**DEVELOPMENT PERMIT STAFF COMMITTEE MEMBERS**

**EXECUTIVE SUMMARY**

To develop this site with a 14-storey mixed use building containing 172 dwelling units (social housing), a social service centre and ancillary retail, all over one level of underground parking with vehicular access from the lane.

THAT the Board APPROVE Development Application No. DP-2021-00481 submitted, the plans and information forming a part thereof, thereby permitting the development of a 14 storey mixed use building containing 172 dwelling units (social housing), a social service centre and ancillary retail, all over one level of underground parking with vehicular access from the lane, subject to the following conditions:

**Figure 4:** The varied heights noted in the DEOD serves an urban design objective to produce a sawtooth block profile.

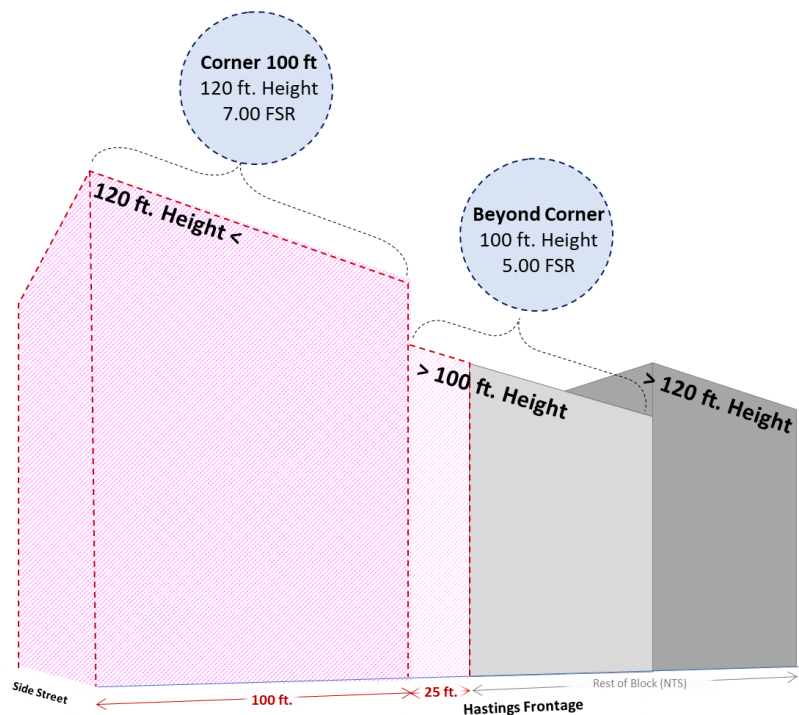
**Frontage:** For the height and density proposed, the allowable frontage should not exceed 30.5m. However, the intent for corner sites such as this is to define the intersections and street corners. Per Section 4.5.3, the DPB may increase the allowable frontage based on consideration of urban design performance and if all residential units are social housing. The applicant proposes a varied roofline, which reinforces the intent of the regulation for a 'sawtooth' street-wall and urban pattern. Staff recommend support for allowable frontage increase up to 38.1m as proposed (See Figure 4).

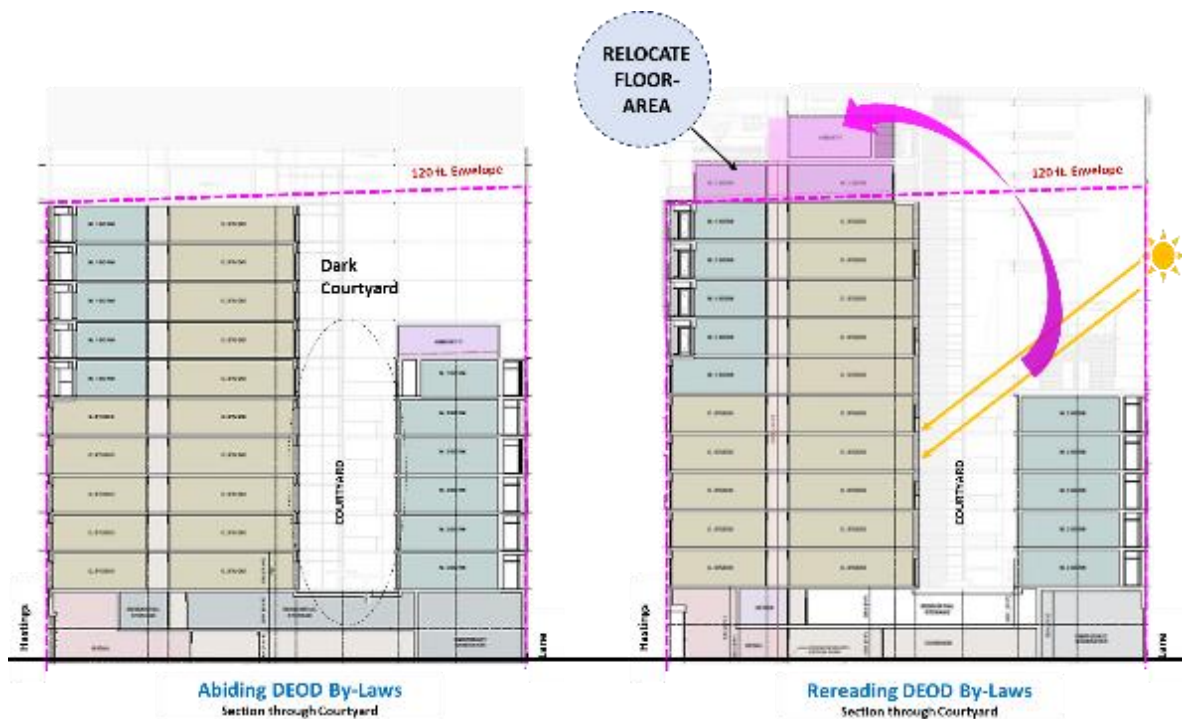
The intention of this floor-area relocation is to reduce the impact and hardships incurred by the site constraints, namely the unconsolidated Southeast corner as demonstrated in Figure 6.

**Staff Review of Applicant's Proposed Response to Height and Massing:**

**Figure 7:** Additional floors / height above the 120 ft. height on the North-Block. (Shaded in Pink) The height at the top of the mechanical units is 150 ft. This is the height the relaxation seeks.

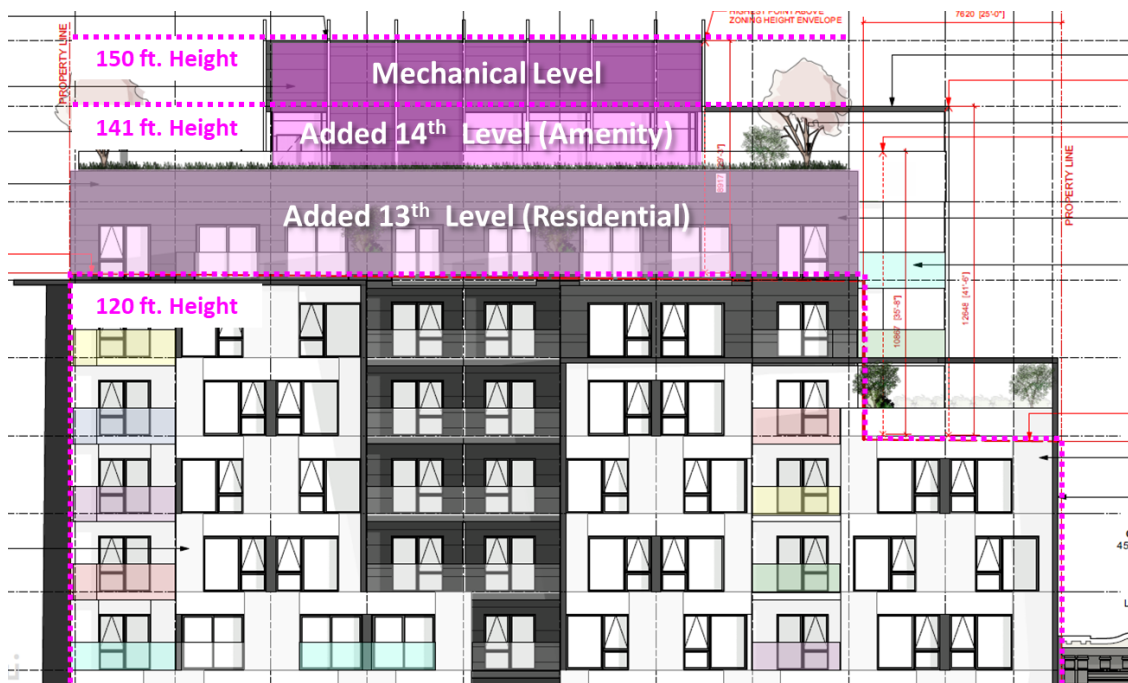
Proposed Structures above the 120 ft. height are solely at the North-Block. This includes a 13<sup>th</sup> level residential floor; and a 14<sup>th</sup> level amenity-room with attached outdoor space for activities and urban agriculture. Mechanical boxes are located above the 14<sup>th</sup> level, with metal screens around to reduce noise and present a logical “cap” to the building (See Figure 7). The top of the mechanical units is measured at approximately 150 ft., which is the height sought for relaxation. Staff note, when viewed from ground-level, the amenity rooms and mechanical levels, which are above the 120 ft. height, are not visually intrusive (See Figure 8).

**Figure 9:** This diagram compares a standard 120 ft. tall DEOD building versus the proposed building's shadows.

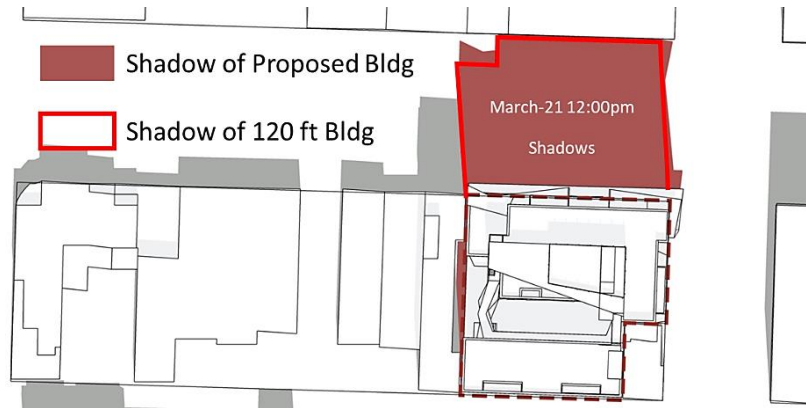
The height increased height does cast moderately longer shadows on Hastings Street. However, as shown in Figure 9, the proposed building's shadow has only a moderate impact than one cast by the base 120 ft. DEOD building. This is achieved with floors above the 120 ft. height being notably setback, lessening the additional shadows impacts.
